Coastal Access Modification Report GAL-MR1

Proposed changes to the submitted England Coast Path proposals
for Gretna to Allonby

Location affected: **Burgh Marsh/Burgh-by-Sands, Cumbria**

9th May 2022

Map GAL-MR1c - Burgh Marsh/Burgh-by-Sands

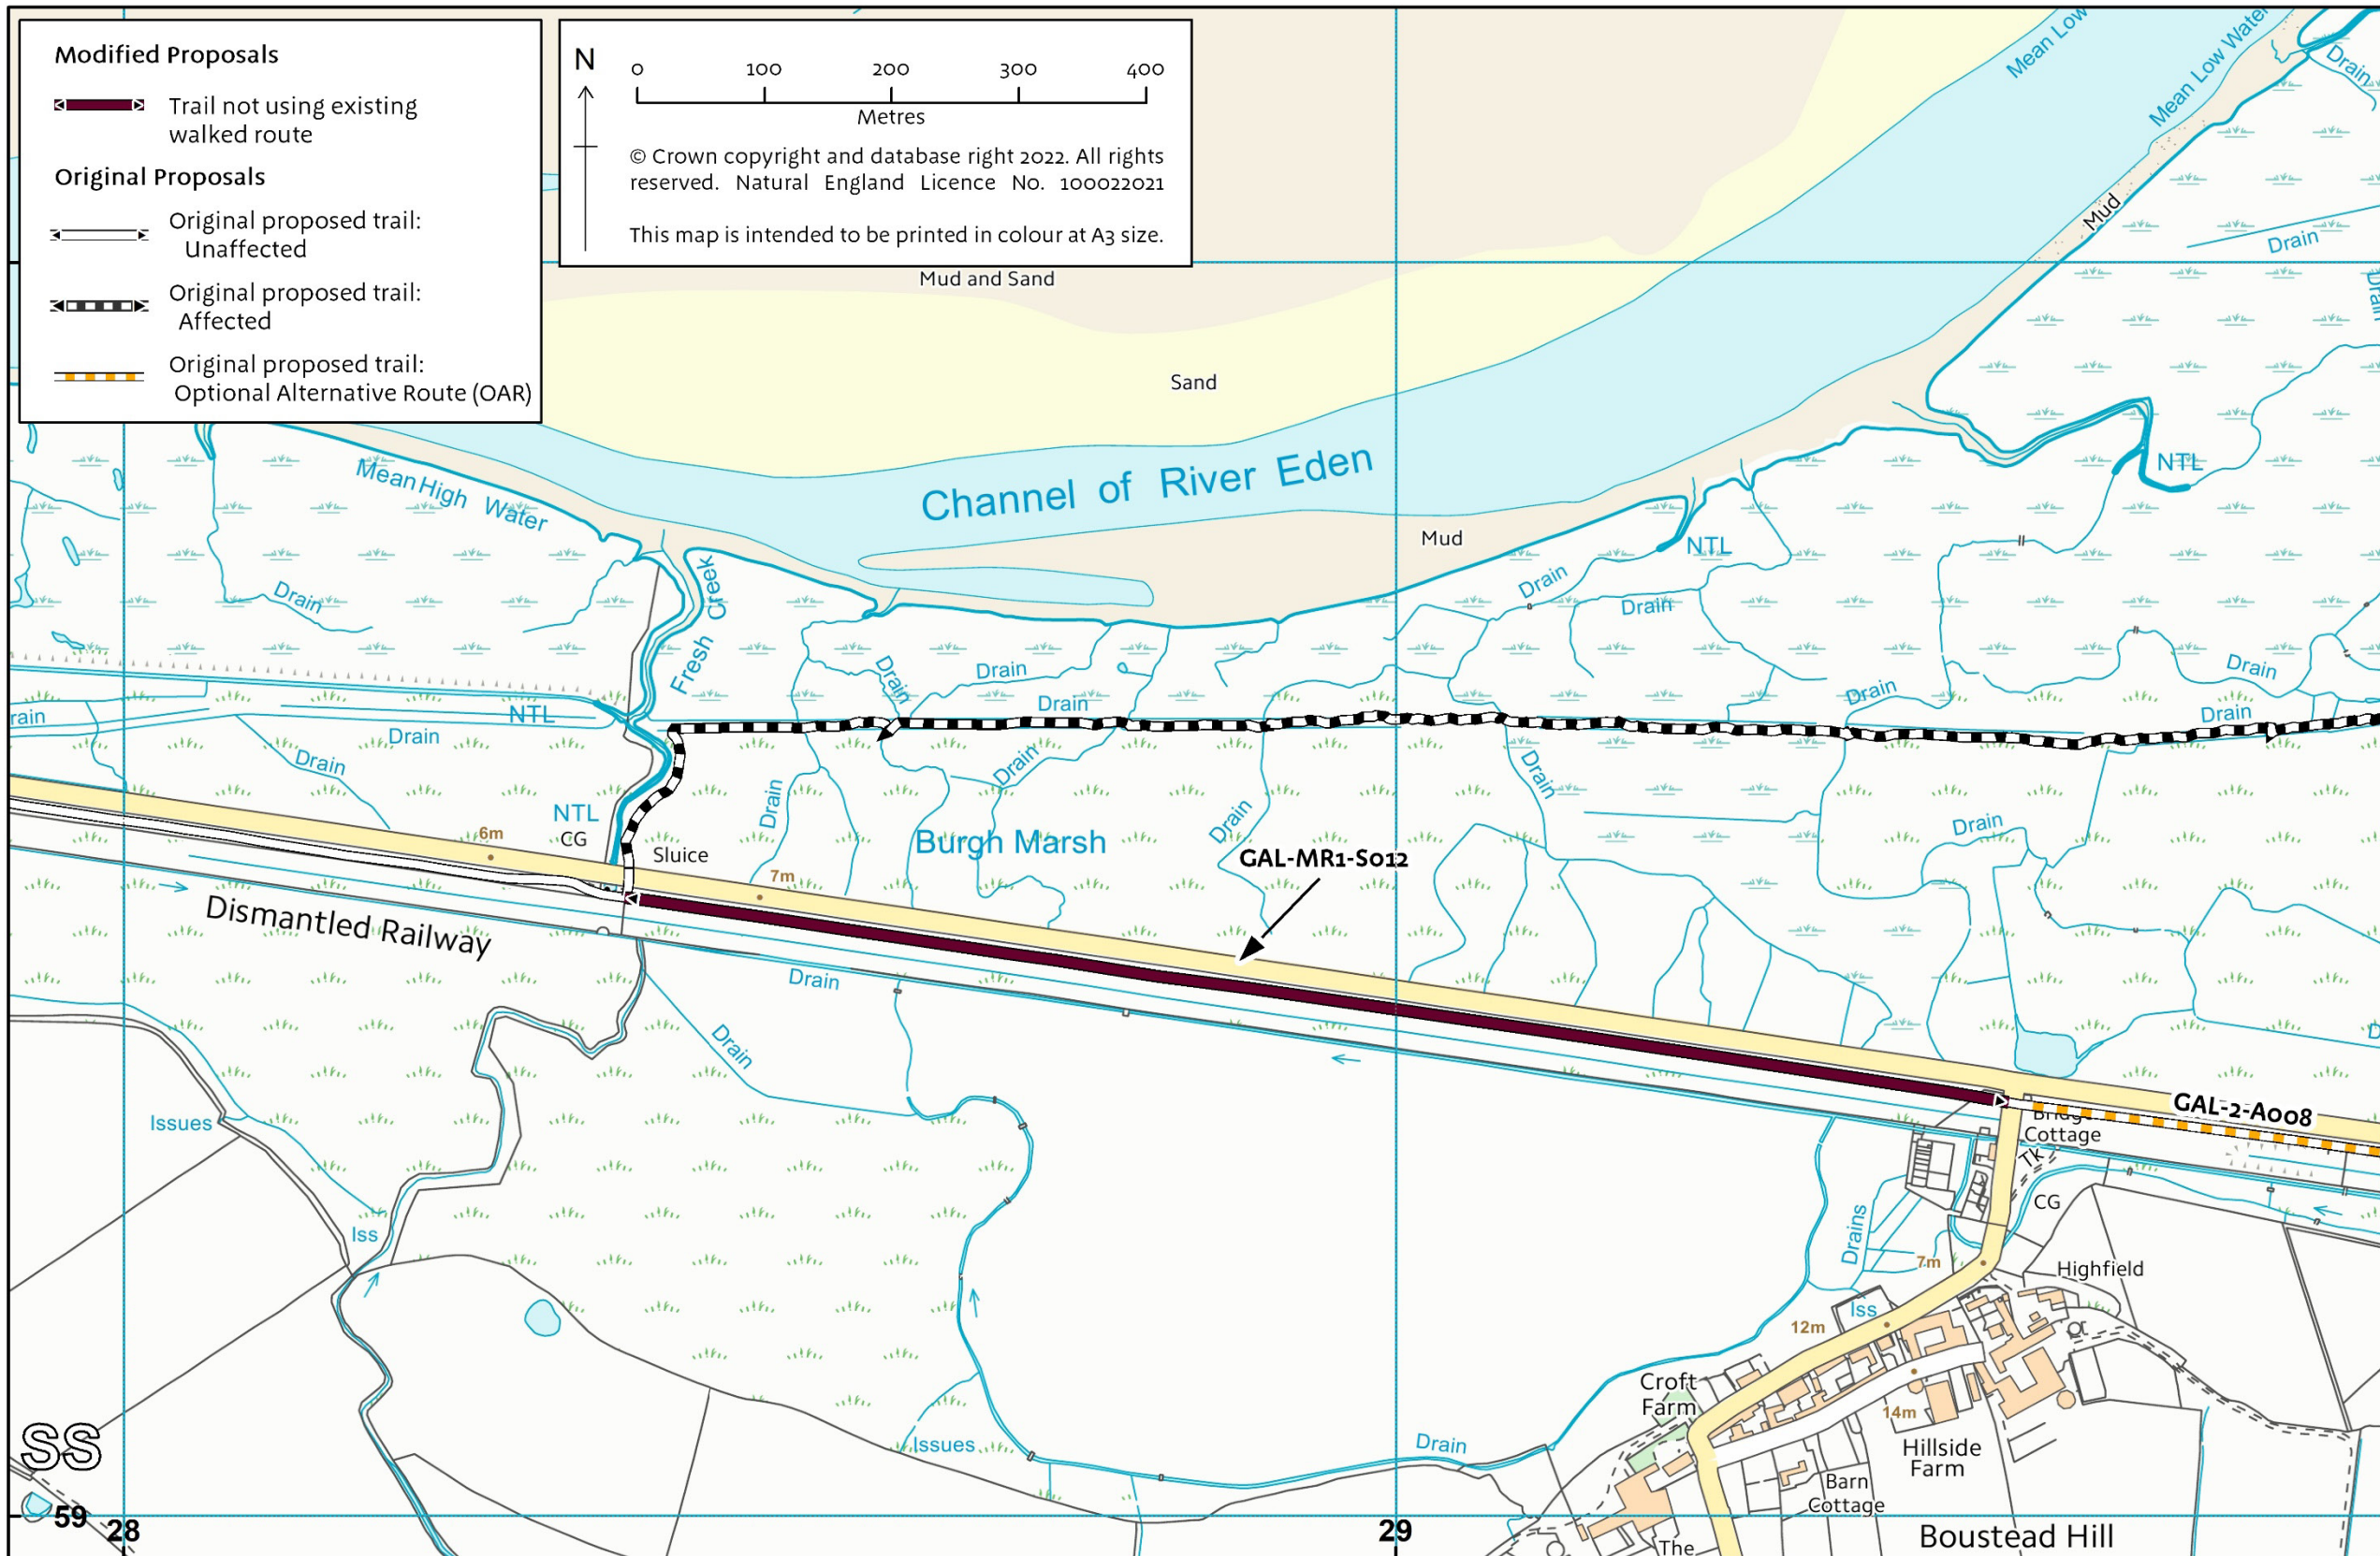
A.2.1 Our proposal (see maps GAL-MR1a to MR1c) is, from east to west, to re-route the path shown as the western end of GAL-2-S068 and all of GAL-2-S069 in our original report. The realigned trail would extend for an approximate length of 3,700 metres, at a maximum of 490 metres landward of the original route proposed.

On sections for which roll-back is not proposed in table A.3.1, the modified route is to be at the centre of the line shown on maps GAL-MR1b and MR1c as the proposed route of the trail.
